RE: Petition for Staff Approved Project Changes for the Mariposa Energy Project
(09-AFC-03)

MARIPOSA ENERGY PROJECT APPLICATION FOR STAFF APPROVED PROJECT CHANGES

Attachment 1
Proposed General Arrangement Drawing
for MEP (09-AFC-3C)

GENERAL ARRANGEMENT

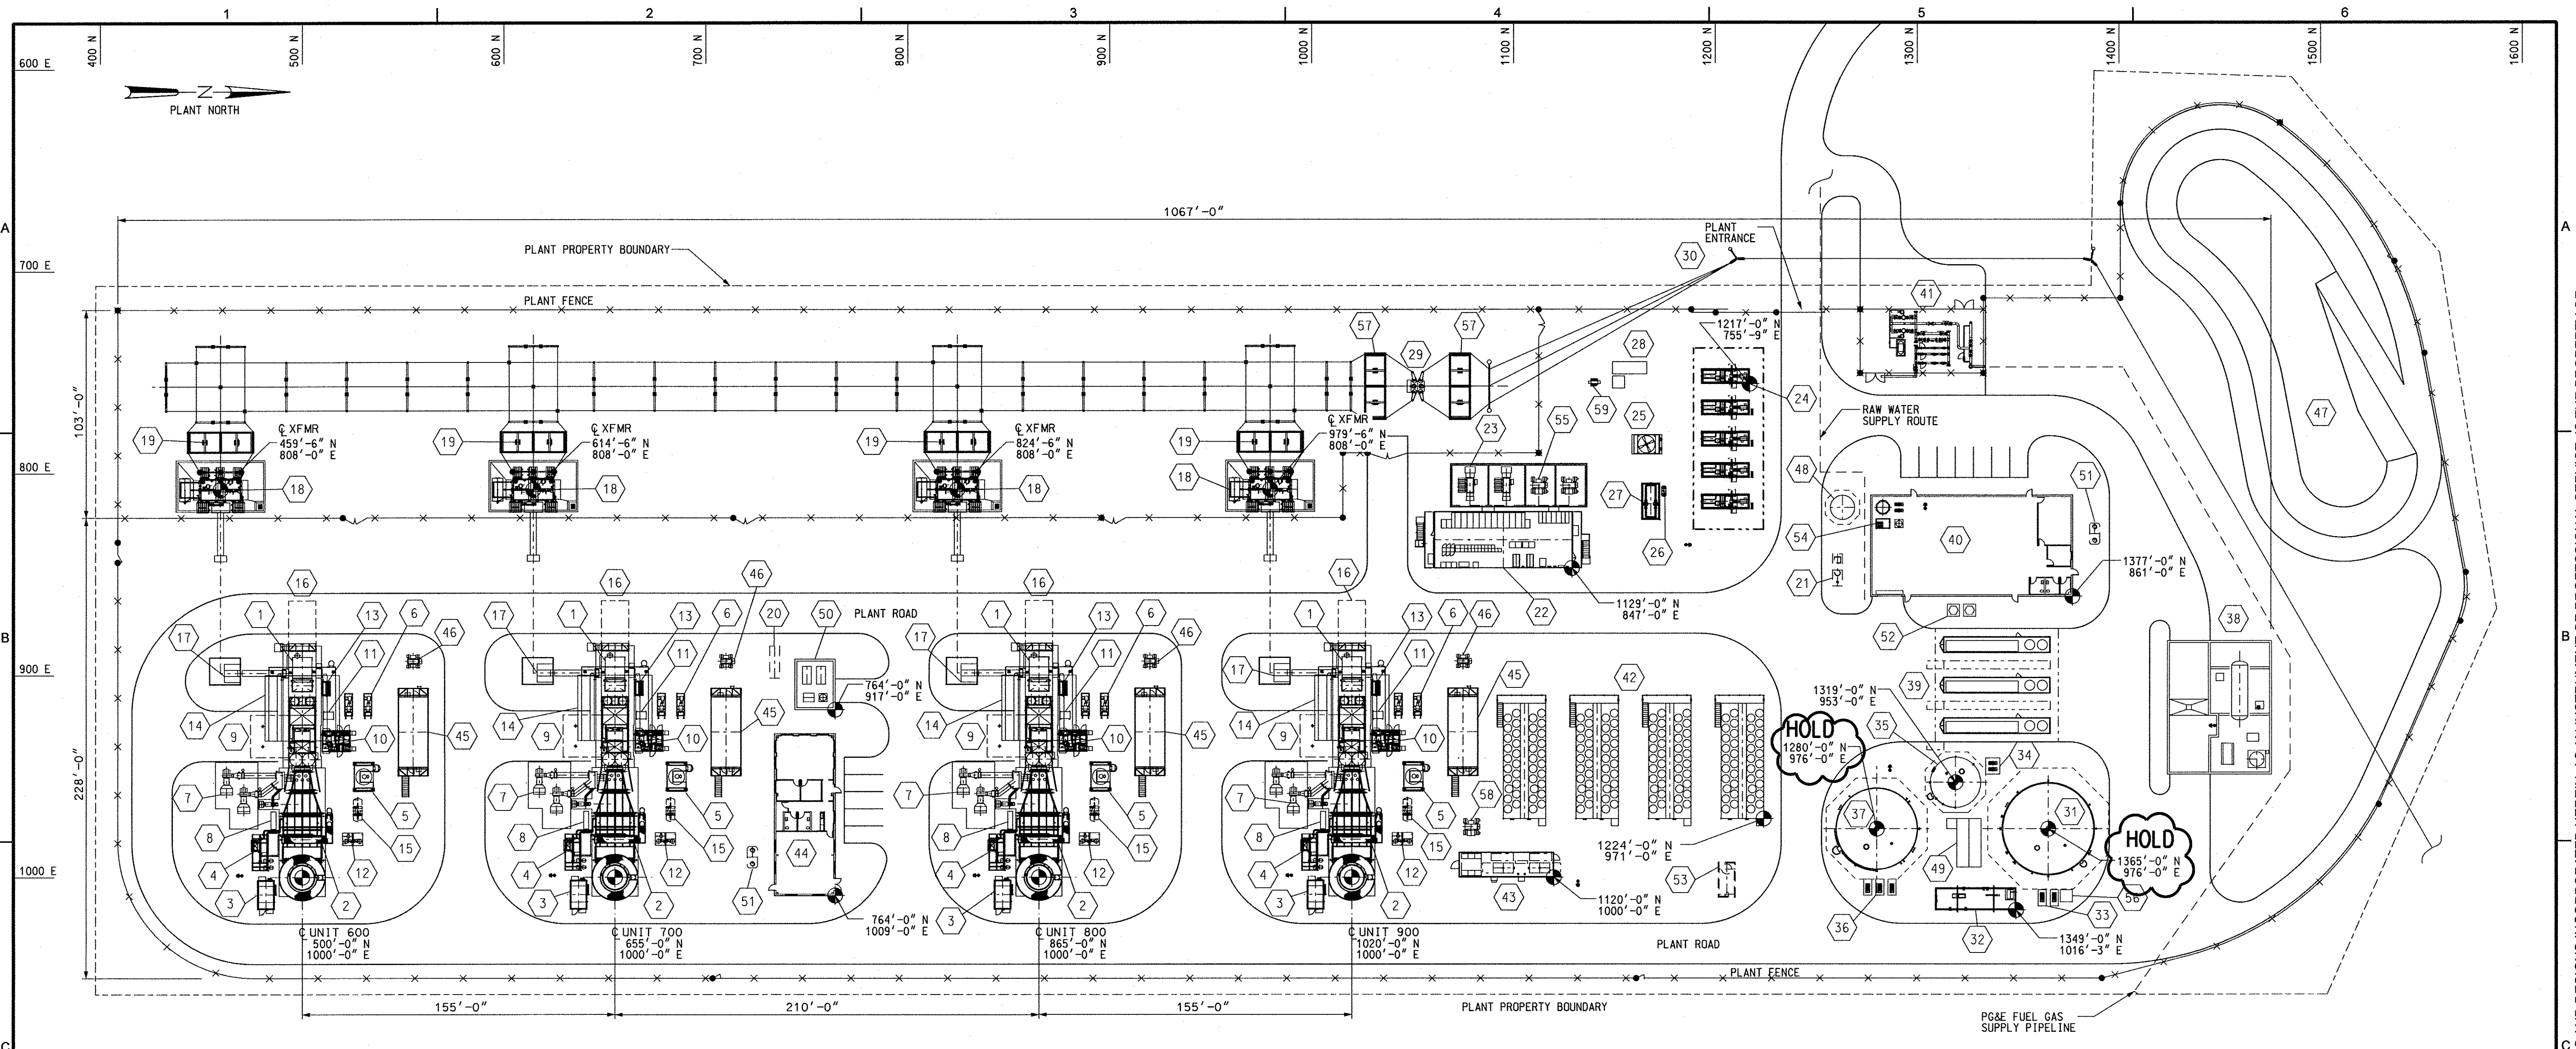
During the final design phase of MEP, Mariposa Energy's engineering contractor determined that the general arrangement drawing included in the Application for Certification (AFC) (Figure 2.3-1) required minor revisions, including the slight shifting of the location of the water storage tanks near the firewater pump, and very minor adjustments to the location, orientation, and configuration of certain other structures and equipment. The water storage tanks require moving because it was determined during the detailed tank foundation design that the footing area had to be larger than the actual tank footprint in order to reduce the soil bearing to allowable levels and prevent seismic overturning. Alternative designs of increasing the depth of the footings or combining the tank foundations did not relieve this condition, so the tank foundation centerlines had to be spaced slightly further apart.

- The wastewater tank move approximately 22 feet southwest.
- The demineralized water tank move approximately 31 feet southwest.
- The raw water tank move approximately 11 feet southwest.
- The fuel gas compressor skids will move approximately 30 feet northwest.
- The Warehouse and Maintenance Building move approximately 50 feet southeast.
- The gas metering station move approximately 80 feet west.
- The 230-kilovolt (kV) circuit breakers, 230-kV disconnect switch, and the generator stepup transformers will each move approximately 20 to 120 feet southwest, respectively.

- Orientation of the power distribution center, auxiliary transformers, and station transformers are rotated 90 degrees counter clockwise.
- The single-unit chiller package will be replaced with a four-unit chiller package. The chiller package will move approximately 43 feet southwest. The original chiller module arrangement depicted on the general arrangement was based on one of multiple potential manufacturers. Chiller module sizes and arrangements vary among potential suppliers, and the current arrangement was not known until final vendor selection was completed. During final bidding, the vendor retracted the design offer originally shown, and the four-unit chiller package shown is the final design selected for the project.

- The four Continuous Emissions Monitoring System (CEMS) shelters move to the southeast side of each stack 25 feet to avoid underground electrical conduit and piping runs. This placement also creates better access for the crane required to service the ECM catalyst during maintenance activities.
